**RE: Response to October 10, 2024 Hearing Comments from Trinkaus Engineering, LLC
Gales Ferry Intermodal
1761 and 1737 Route 12, Gales Ferry, Connecticut
Commission Number 45JC206**

On behalf of our client, Gales Ferry Intermodal, LLC, Loureiro Engineering Associates Inc. (LEA) has prepared this letter in response the comments from Trinkaus Engineering, LLC (Trinkaus) at the October 10, 2024 hearing. This document presents the paraphrased comments in italic followed by LEA's response in vertical roman text.

**INDUSTRIAL SITE PREPARATION PLAN:
GRADING AND DRAINAGE PLAN**

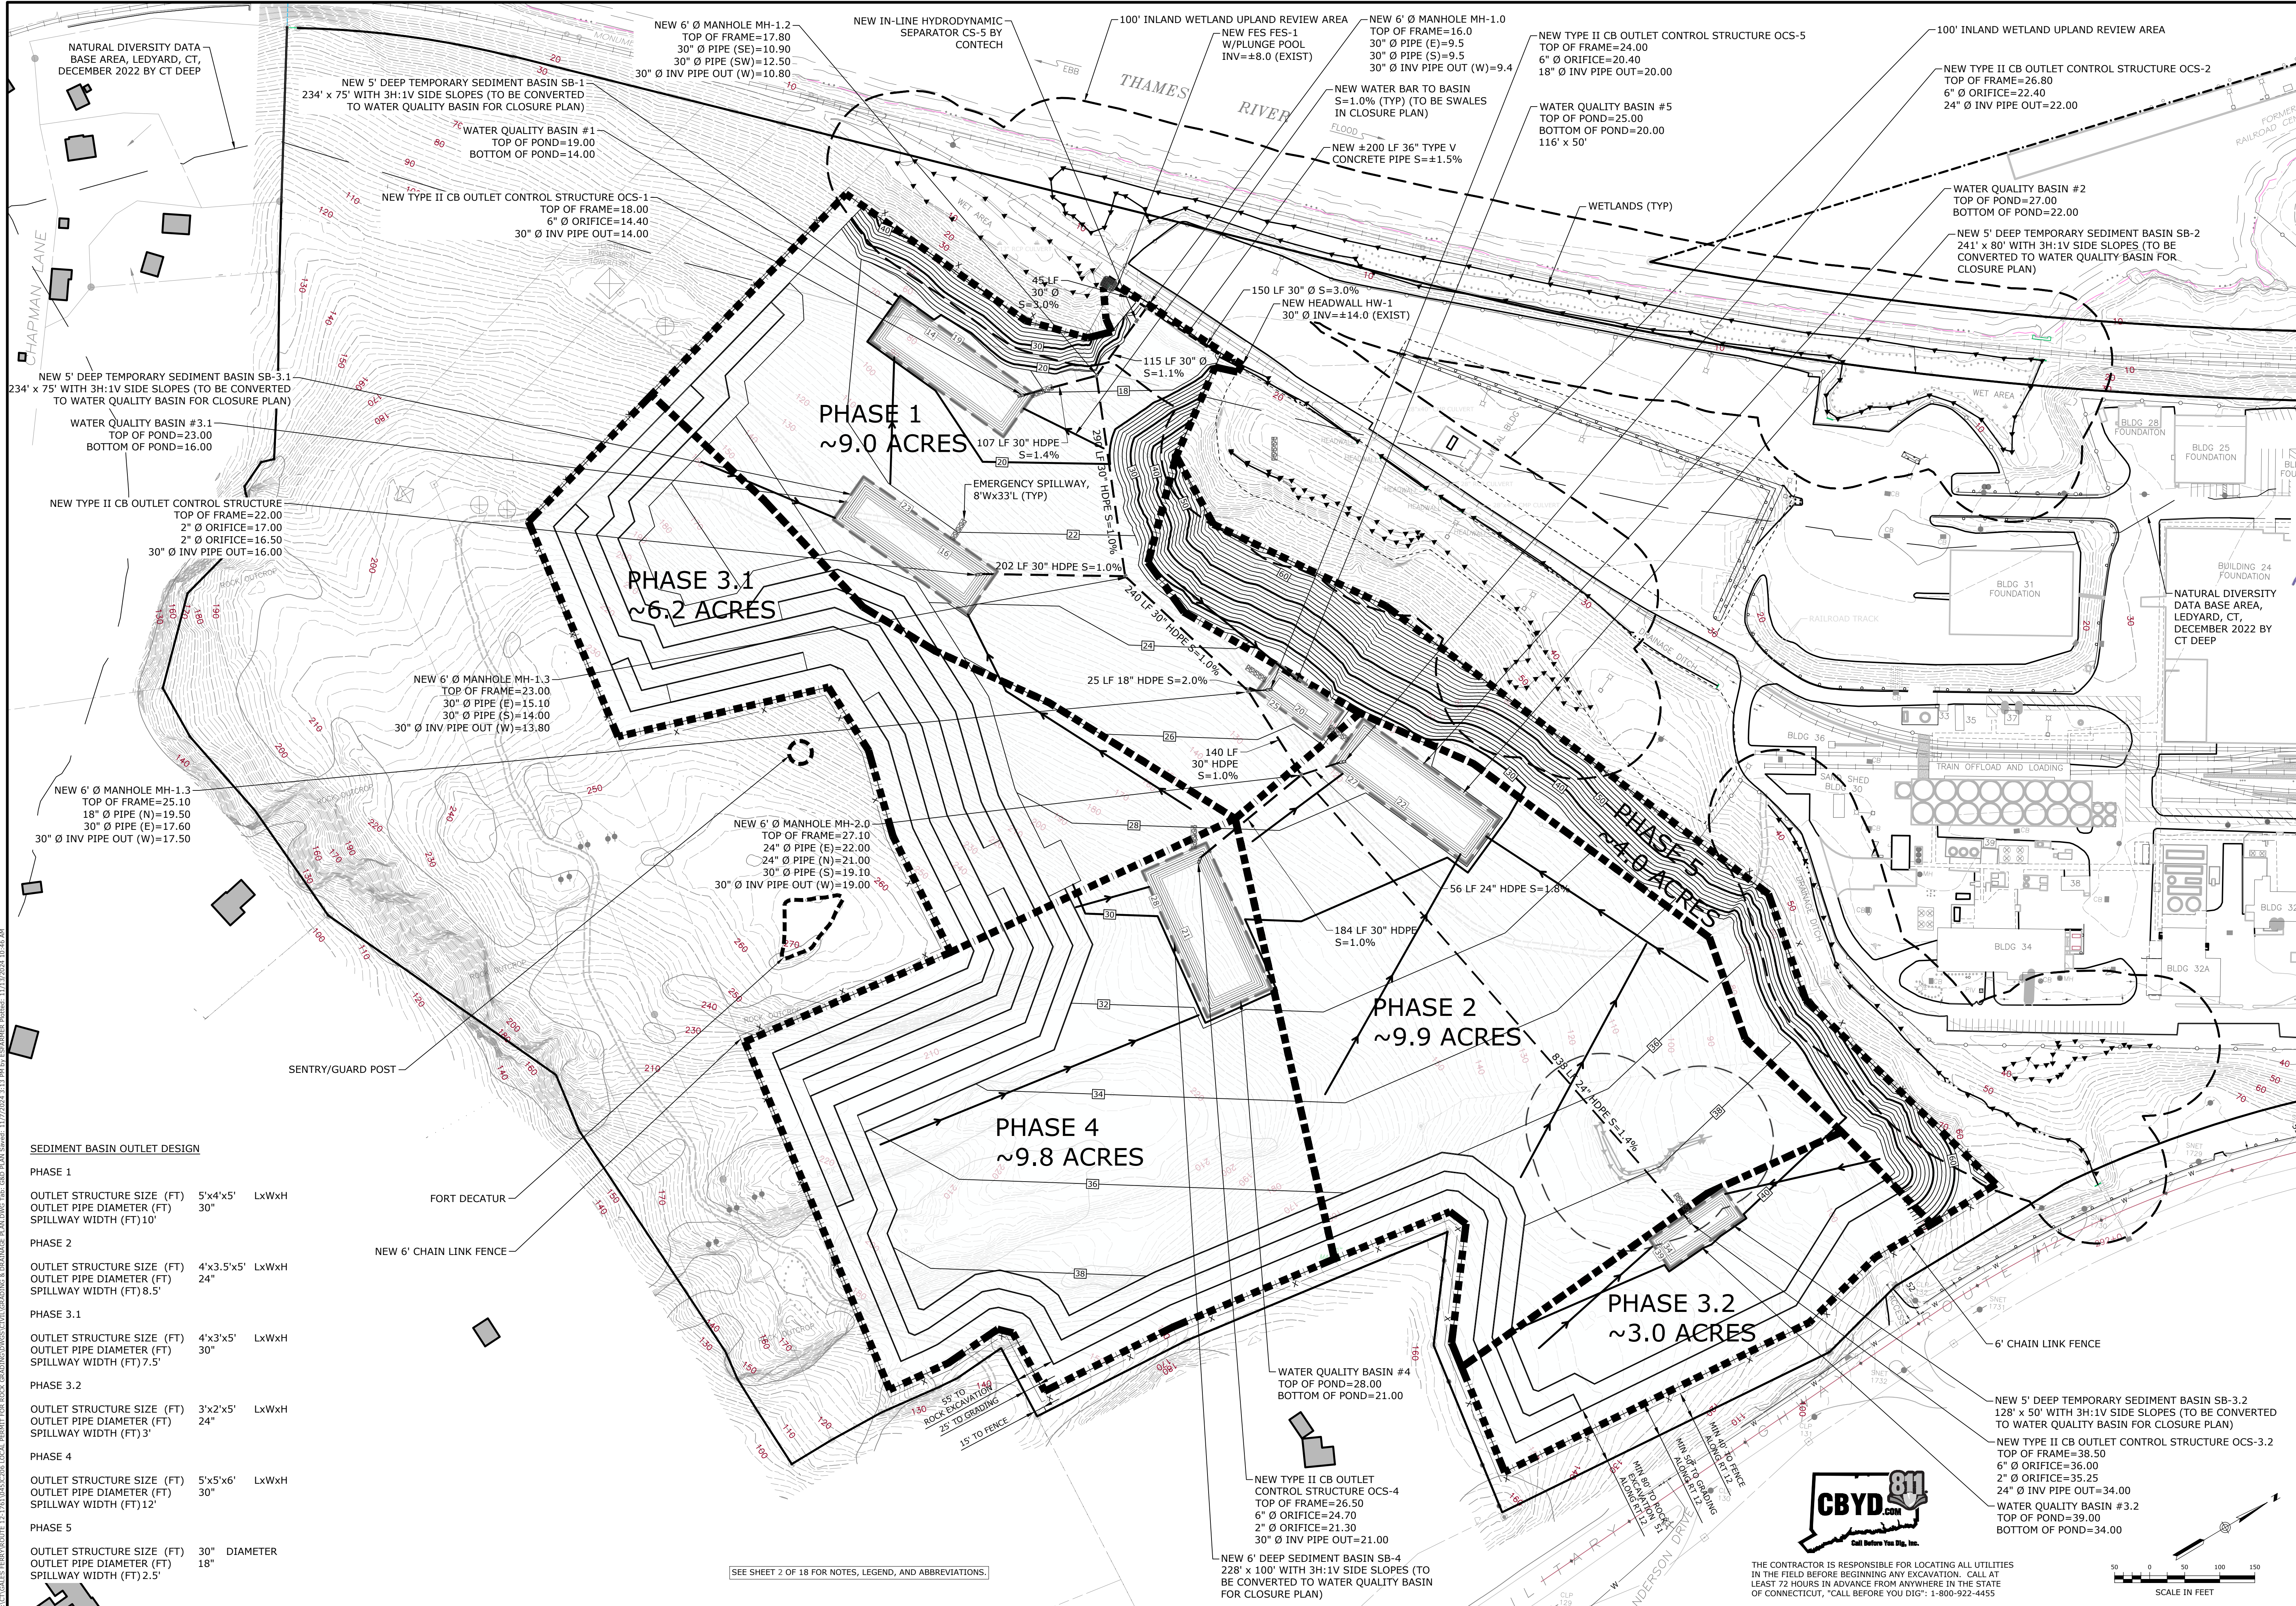
The temporary stormwater basins shown at an elevation in bedrock after blasting. Nothing shown for the start of the program.

At the start of the project, the excavation of overburden soils will be underway. The lower portion of the excavation area is expected to have 25-30-feet of overburden soils, which will clearly provide more than adequate room for the contractor to establish the first temporary sediment basin for the project. The general location would generally replicate the final location shown on the drawings, albeit the temporary basin will be at a higher elevation. The volume computations are included in the drawing set to facilitate this situation. It is noteworthy that the overblasting will extend down to elevation 5, which is well below the entrance elevation. Bedrock will not be exposed at the entrance to the excavation near the railroad tracks, as this will be in overburden. This further contains runoff and sediment inside the excavation area during the initial excavation process, so multiple lines of protection are provided.

Specific details are included in the Stormwater Pollution Control Plan (SWPCP) prepared for this Site in accordance with the Connecticut Department of Energy & Environmental Protection's (DEEP) Construction Stormwater Permit (Attached), which registration will be completed after local approval of the project.

DRAWING
C-5

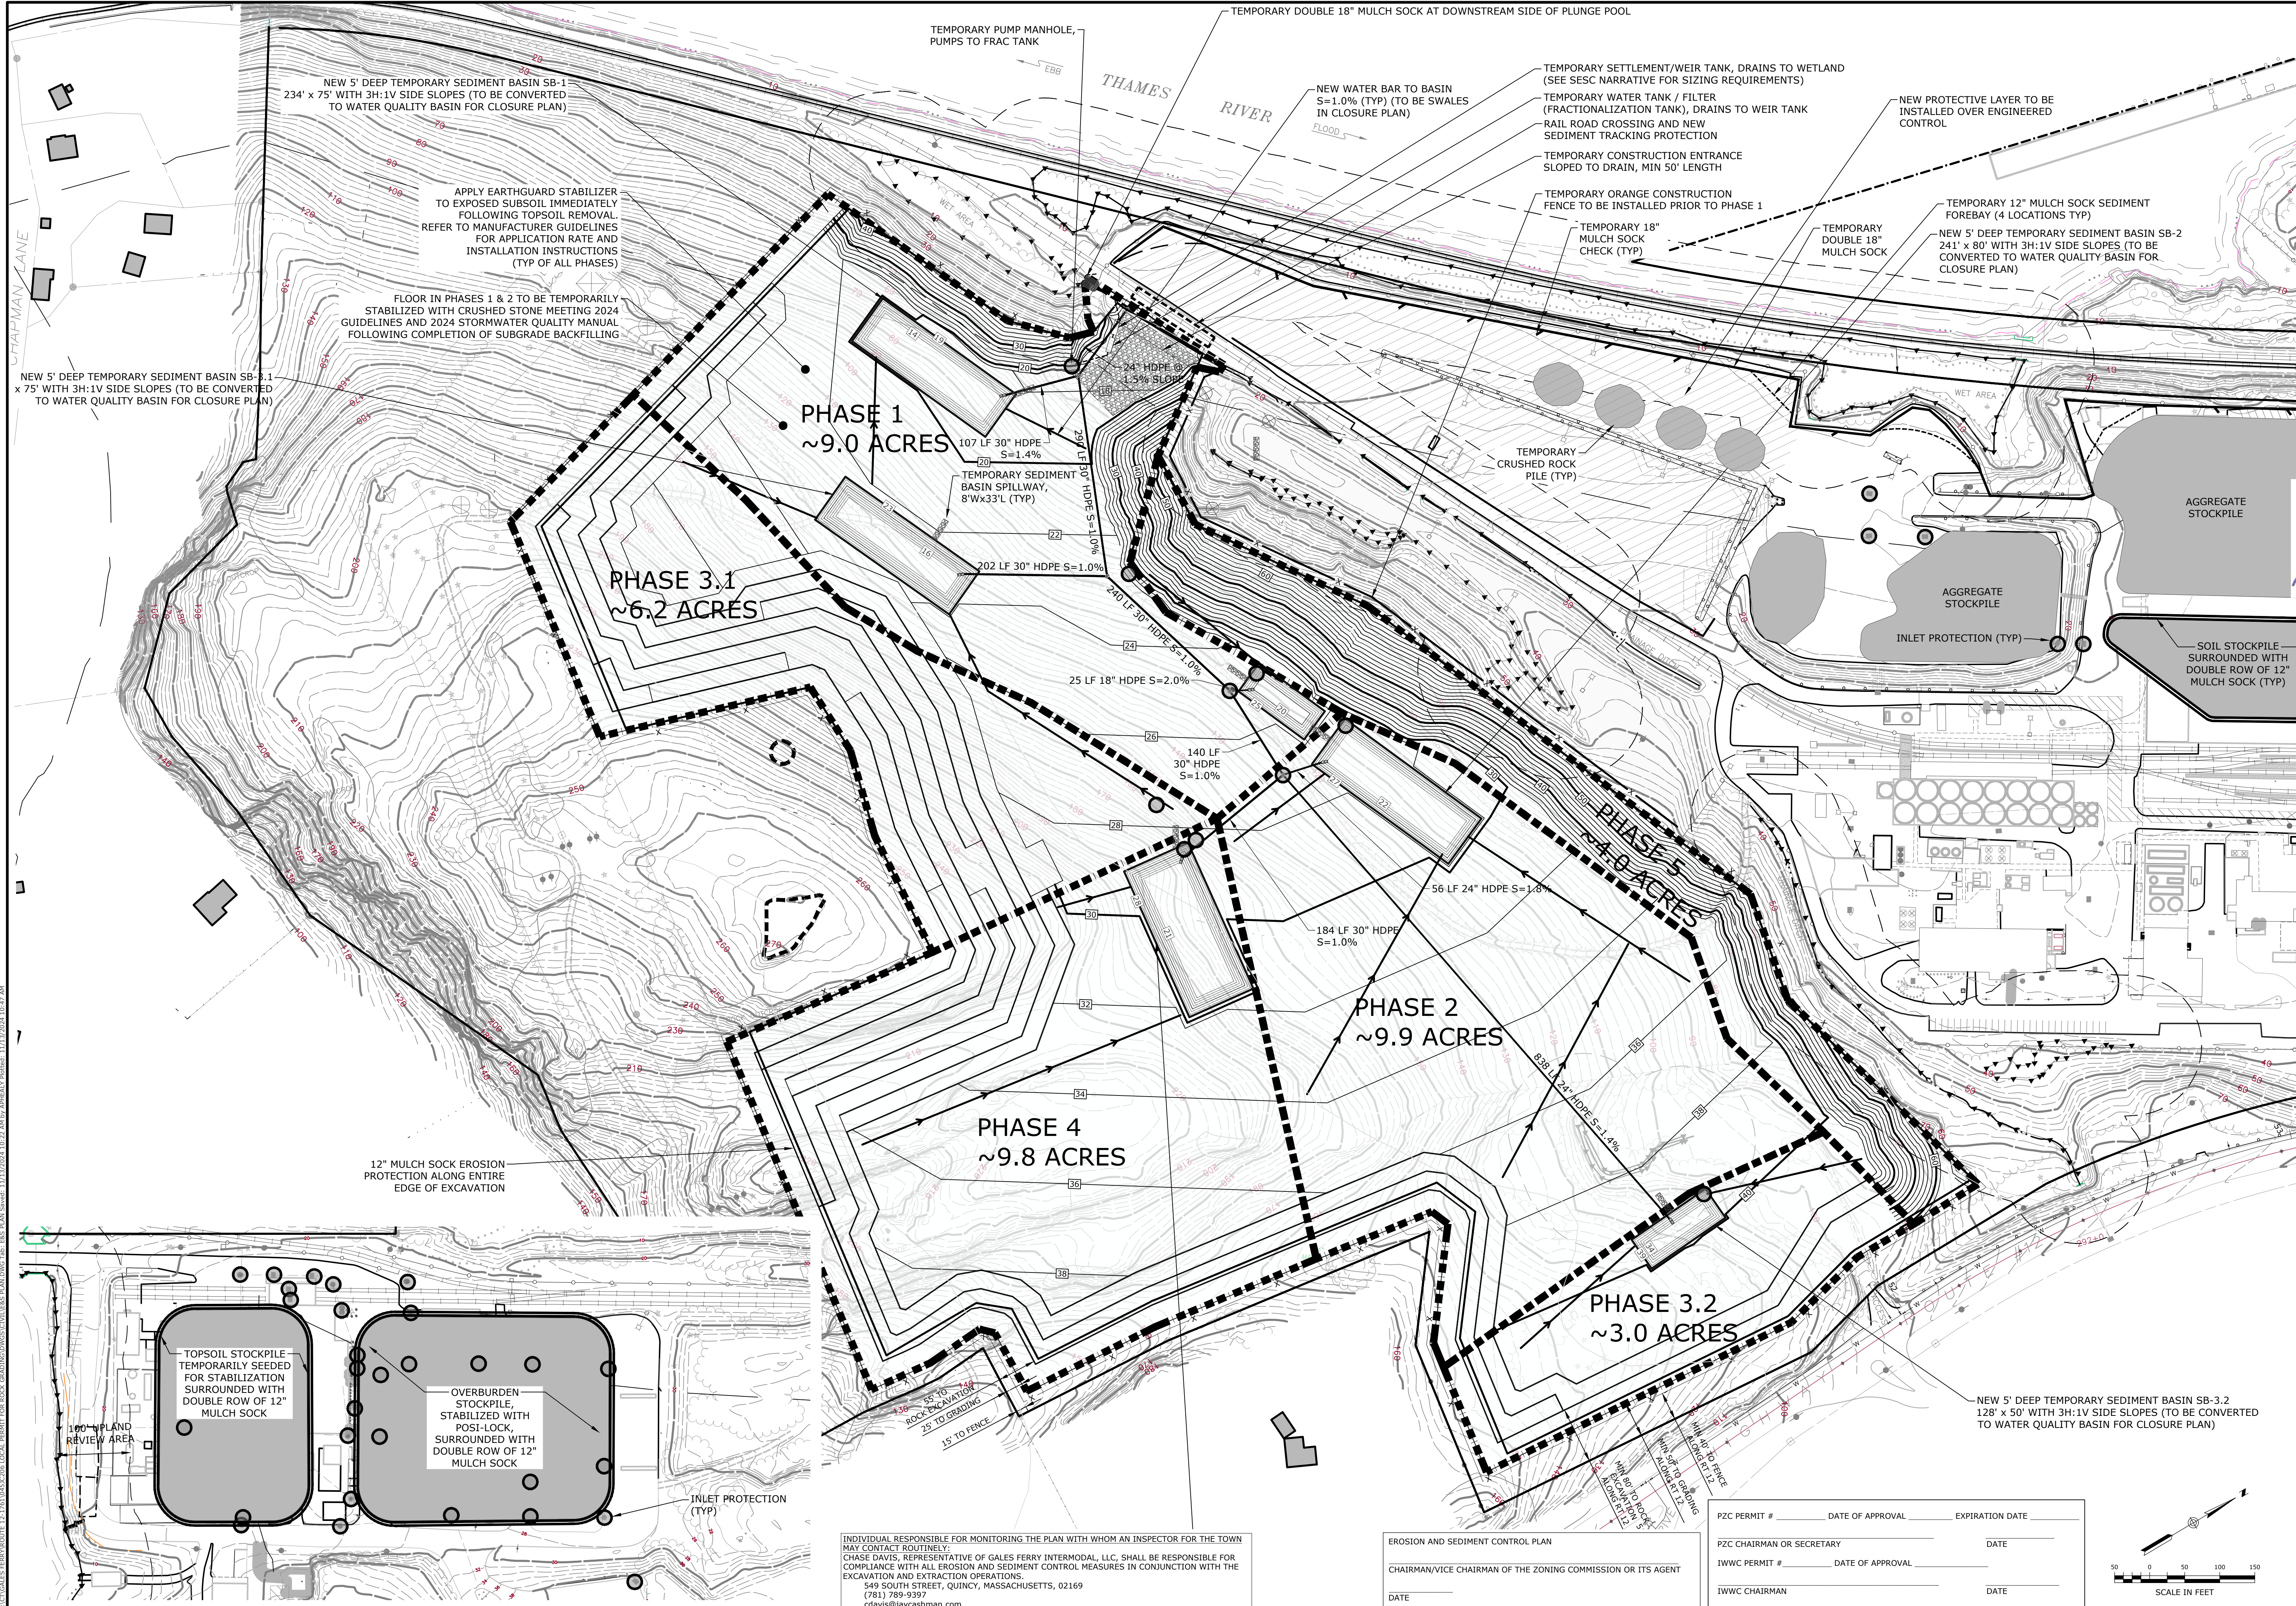
Need higher more robust soil erosion control for > 5 acres of disturbance.

Wants a detailed phasing plan showing all the basins as the project progresses – This heightened level of detail is included in the SWPCP, which is typically prepared after local approvals in pursuit of the DEEP Construction Stormwater Permit registration. It is important to recognize the contractor’s ability to locate basins as needed to progress the work based on site conditions, which may result in slight locational changes as the phases progress.

Each work phase is equipped with adequately sized sediment basins. Surface treatments will be applied as needed during construction including the use of woodchips generated from the site. Surface treatments including Intermittent mulch socks will be installed throughout the areas opened up to grading to mitigate significant erosion during the overburden stripping process. Stormwater will initially be confined to the work area and subject to natural infiltration and/or dewatering as needed after significant storm events then treated prior to discharge into the existing area of infiltration.

As the first phase excavation concludes, the working floor will be further filled with existing soils derived from the overburden removal process to ensure that similar infiltrative capacities can be established. The sediment basin within the phase will be fully established and the surface will be stabilized with crushed stone to mitigate erosion. The next phase will be accomplished similarly with the working floor within the next phase at a lower elevation than the first phase elevation thereby always containing stormwater within the active phase.

Further details are provided in the SWPCP.
